**CITY OF TEMPE
DEVELOPMENT REVIEW COMMISSION**

**Meeting Date: 02/11/2014
Agenda Item: 3**

ACTION: Request for a Use Permit to allow a Mini-Warehouse Facility expansion and a Development Plan Review consisting of a new two-story building addition for TEMPE STORAGE COMPANY, located at 822 South McClintock Drive. The applicant is R.B. Williams & Associates Inc.

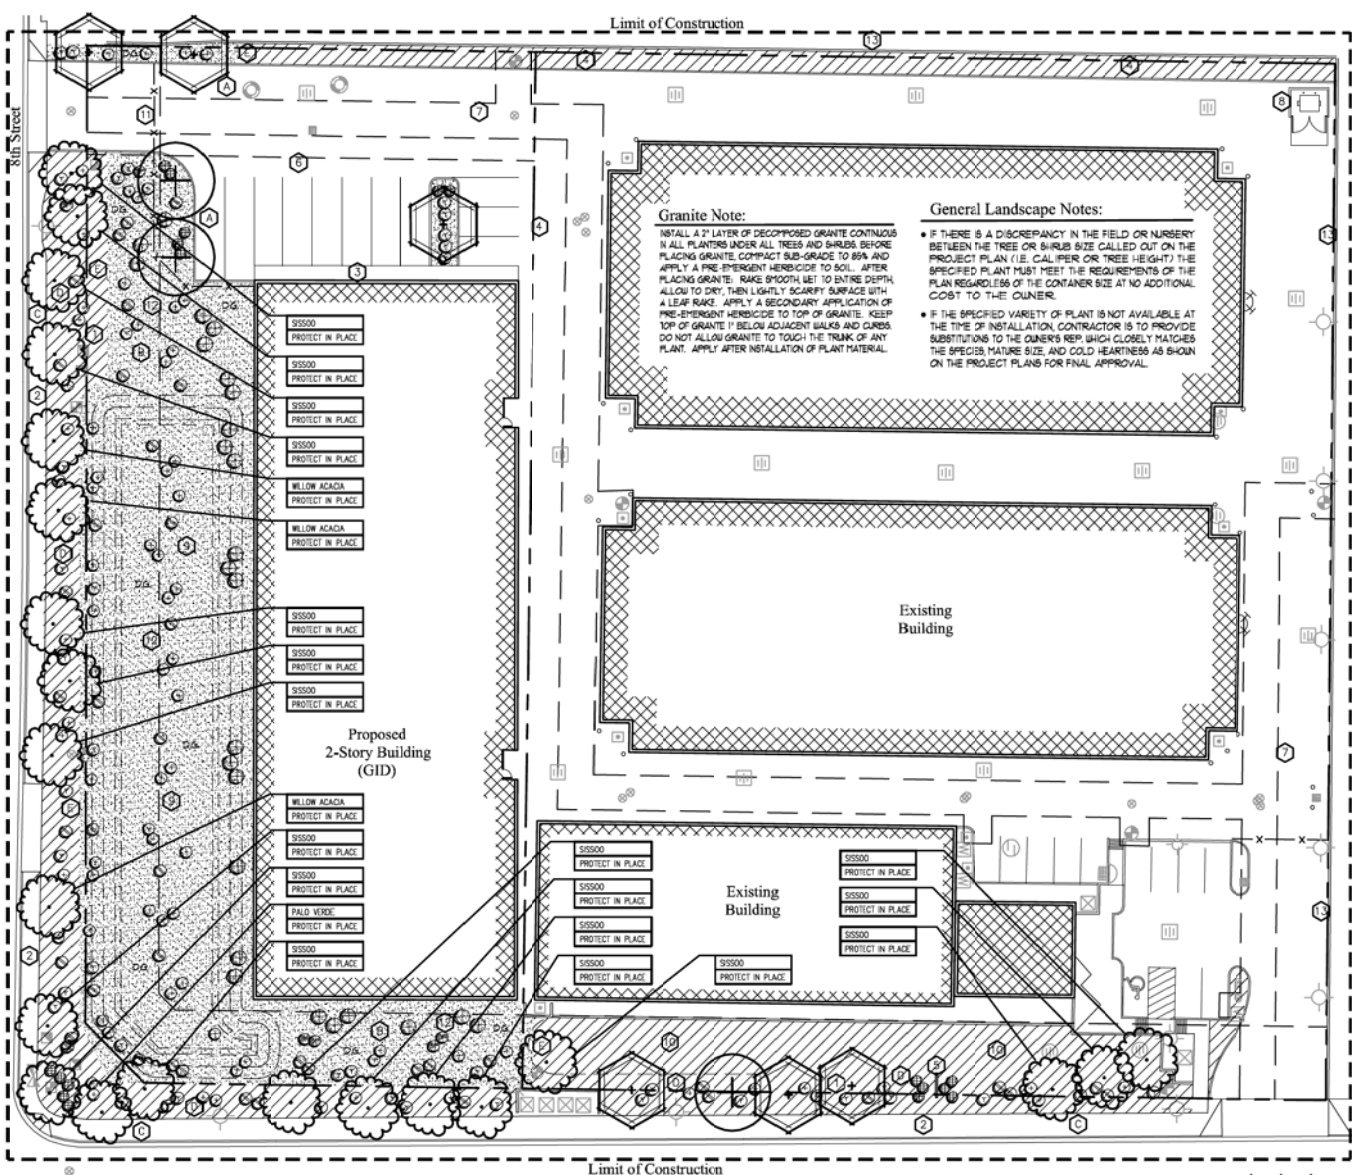
The landscape plan for the site is a continuation of the previous approved plans for the street frontage. There is no proposed internal landscape except for the required landscape island at the end of the new parking row. The original project was required to provide landscape and street trees along the 8th Street frontage. This plan intends to preserve the existing trees and supplement the remaining area which will also be utilized for surface retention area. A proposed stipulation has been added to address any significant use of retention in the landscape frontage. The Code limits only 2/3rds of the landscape frontage may be used for retention purposes. Potential modifications may be required for the plans.

14. The plant palette is approved as proposed and specified on the landscape plan. Any additions or modifications may be submitted for review during building plan check process.

15. Provide additional shrubs and groundcover plants to the plan, increasing the ground coverage to at least 30% of the landscape area.
16. Do not propose a retaining wall to accommodate any increase surface retention slope that would require a safety railing.

17. Replace any dead or missing trees and shrubs on the improved portion of the site. Indicate notes and add missing plants on the landscape plan, as part of the building permit plan set.
